JLRTB02065NAS1

**TECHNICAL BULLETIN**

Rattle Noise From Under The Vehicle

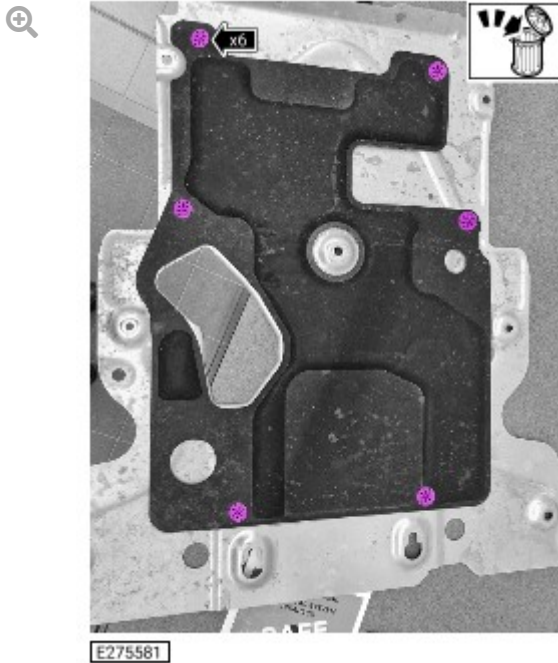
Remove and discard the 6 star washers.

E275670

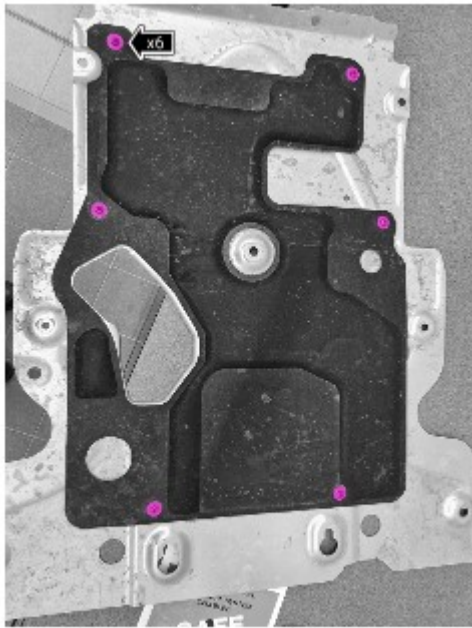
Install the 6 new nuts.

- ■ Torque: **3 Nm**
